# UNITED STATES PATENT AND TRADEMARK OFFICE

APPLICATION NO.	FILING DATE	FIRST NAMED INVENTOR	ATTORNEY DOCKET NO.	CONFIRMATION NO.
10/738,364	12/17/2003	Theodore B. Mulle	2066/U	8555

<b>Office Action Summary</b>	<b>Application No.</b>	<b>Applicant(s)</b>	
	10/738,364	MULLE ET AL.	
	<b>Examiner</b>	<b>Art Unit</b>	
	Faye Francis	3725

### **DETAILED ACTION**

**FIG-1**

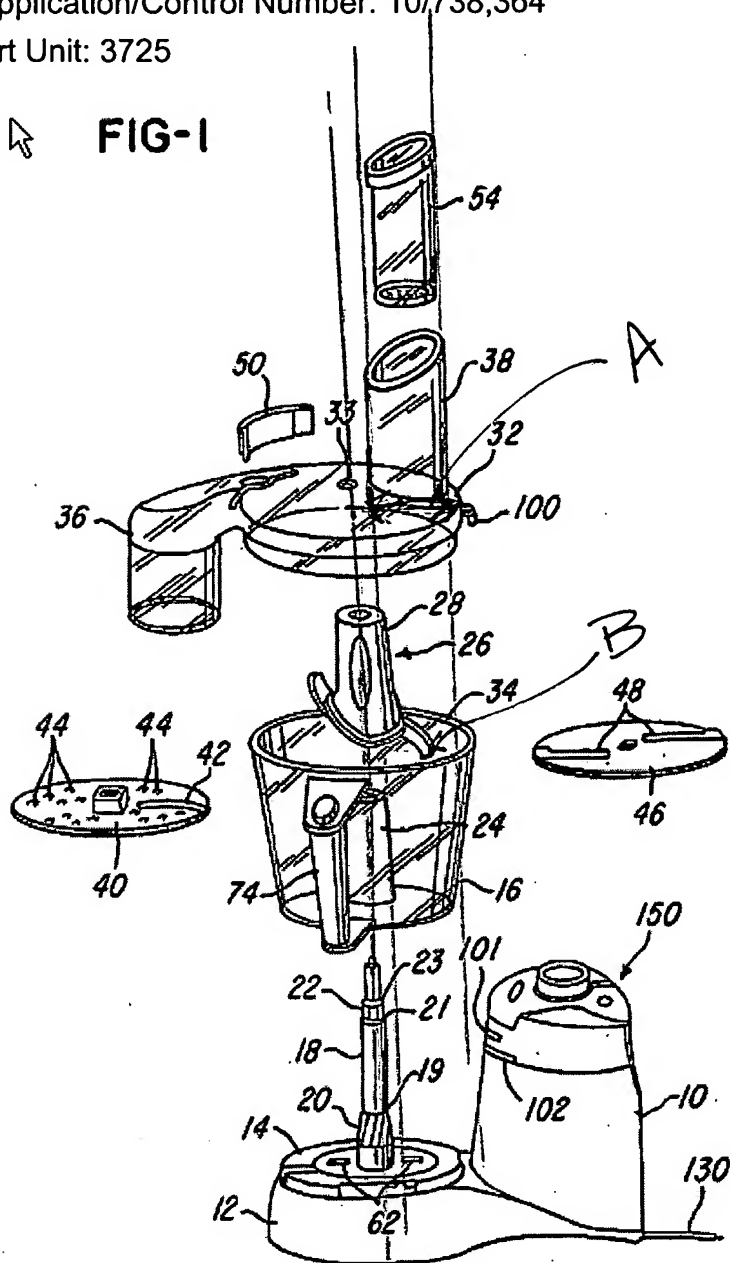
Brady discloses in Figs 1-12 (also see Figure below wherein the letters A-B have been added by the examiner), a cover assembly for food processing appliance comprising: a cover [lid 32] for cooperating with a container [body member 10, base 12

and bowl 16], the container cooperating with an operating base 12 and 14, the cover having an upper side with a predefined ingress area A, the operating base having a rotating tool 98 with a center of rotation [shaft 18] and a peripheral impact region B and the peripheral impact region being radially distanced from the center of rotation. Also, Brady discloses an accessory [pusher 54] for cooperating with the ingress area, wherein the ingress area overlies at least a substantial portion of an outermost portion of the peripheral impact region relative to the center of rotation and wherein the ingress area does not overlap the center of rotation [see the Figure below] when the cover operatively connected to the container and the container is operatively connected the operating base [shaft 18 enters the bushing 33, see col 6 lines 28-48 and Fig 1] as recited in claims 1, 7 and 13. Additionally, Brady discloses the ingress area has a cross-sectional area **substantially equal** to half that of a lower side of the cover [see the Figure below] as recited in claims 2, 8 and 14 and the ingress area is shaped so as to overlay at least a distal end of the impact region [see the Figure below] as recited in claims 4, 9 and 16.

Therefore, Brady does not disclose a cover assembly for a food processing appliance "wherein said ingress area overlies at least a substantial portion of an outermost portion of the peripheral impact region relative to said center of rotation," as recited in claim 1. In response, the examiner would like to draw the applicant's attention to the above Figure. Applicant should note that the argued limitations are clearly disclosed by Figure 1 of Brady, given the broad reference frame as claimed and disclosed, the relied upon reference shows and meets such broad limitations.
